## SUPER I/O

# DC Jack/1394

## Change note:

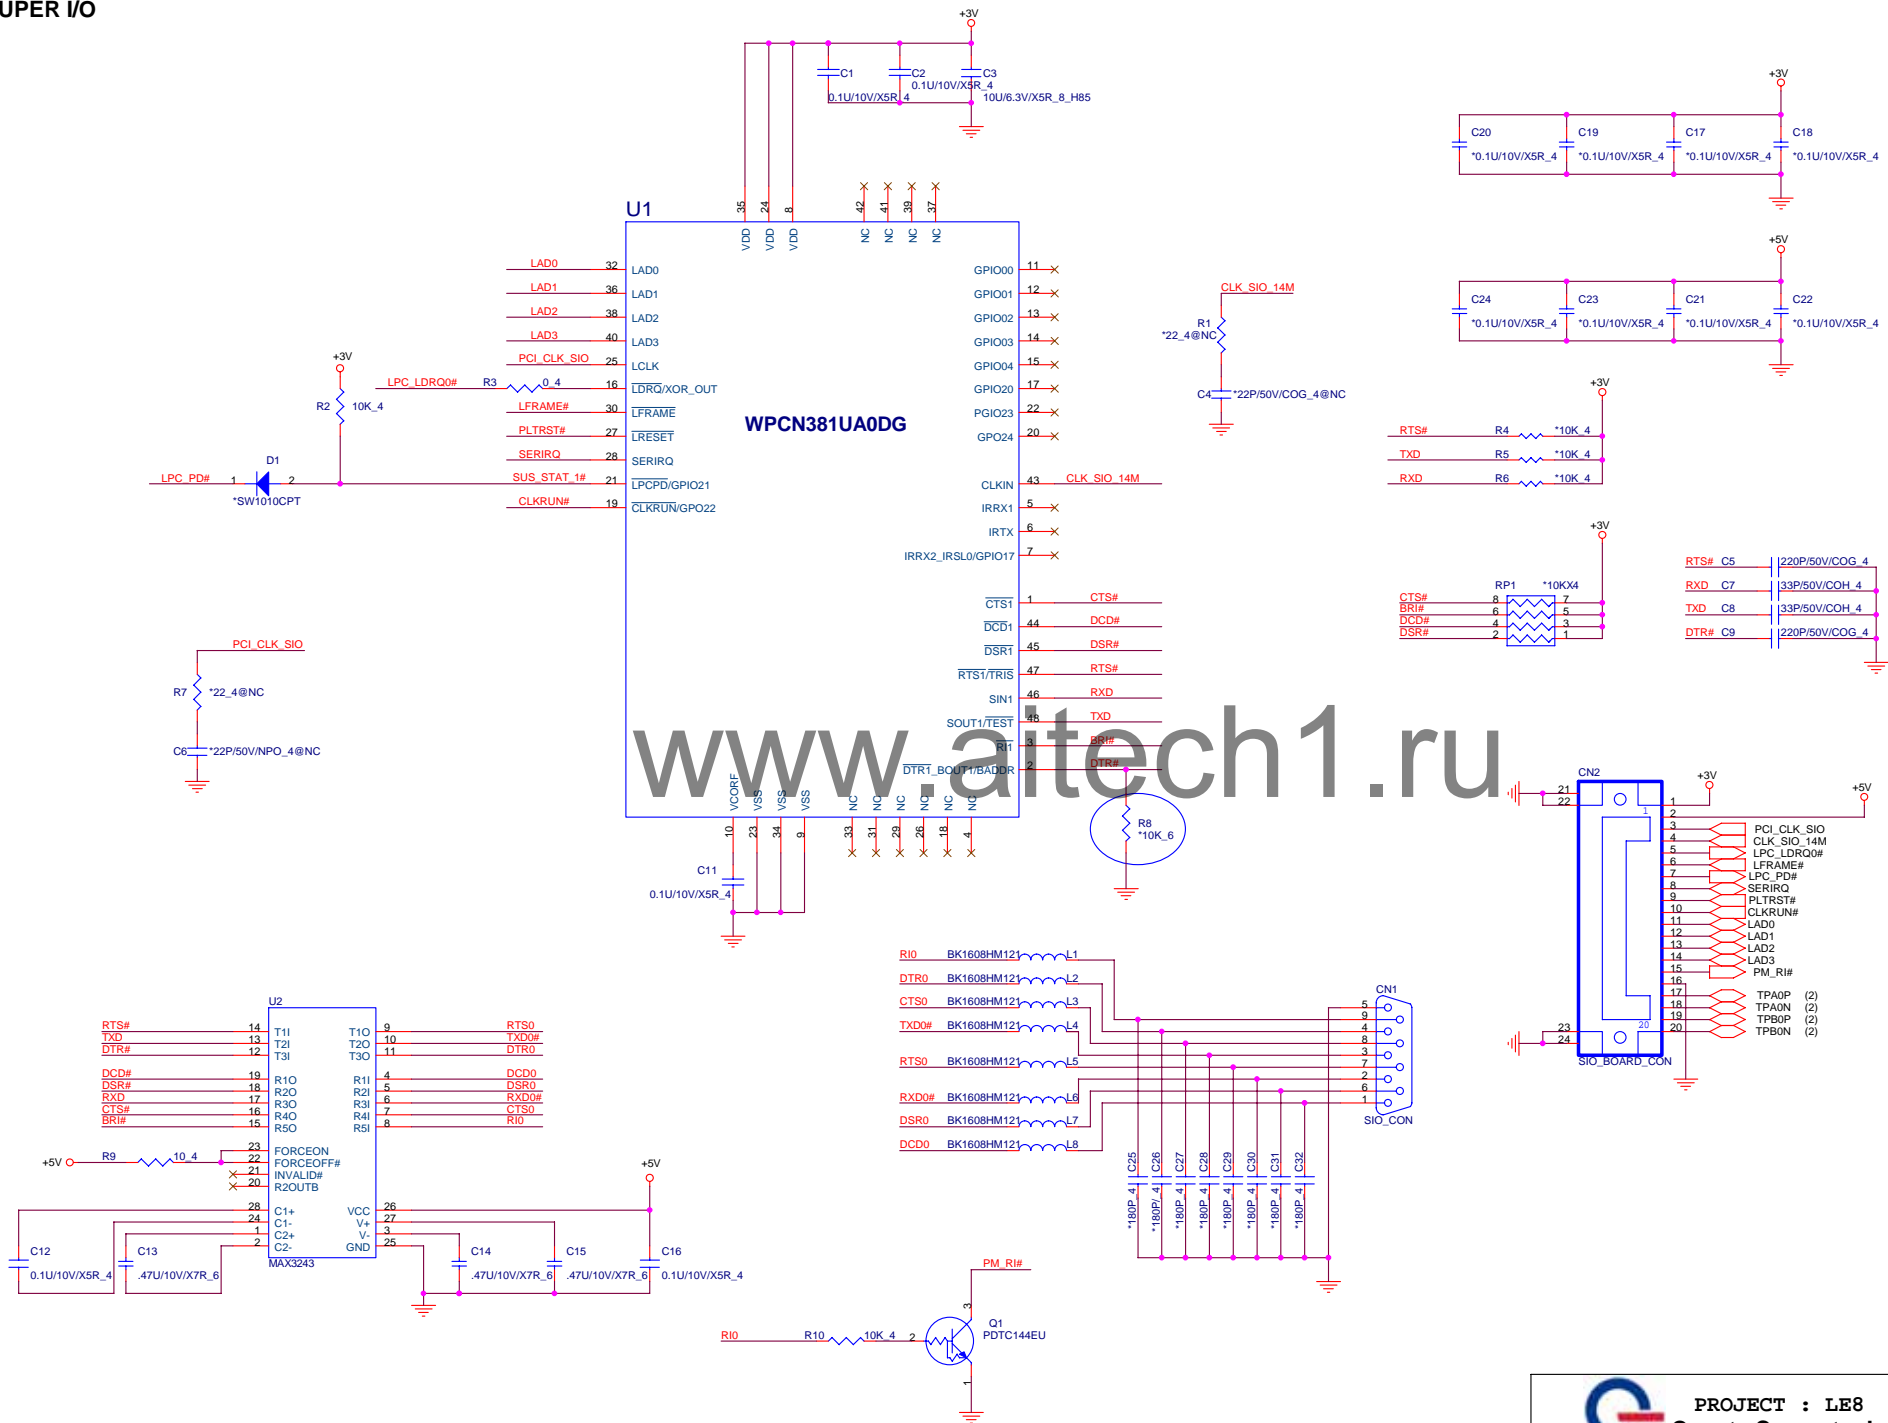
1. Change PJ2 and CN3 Part Number
2. Populate bead BK1608HM121 L1 to L7 in serial port
3. Add 180 pF C25 to C32 parallel connection to serial port
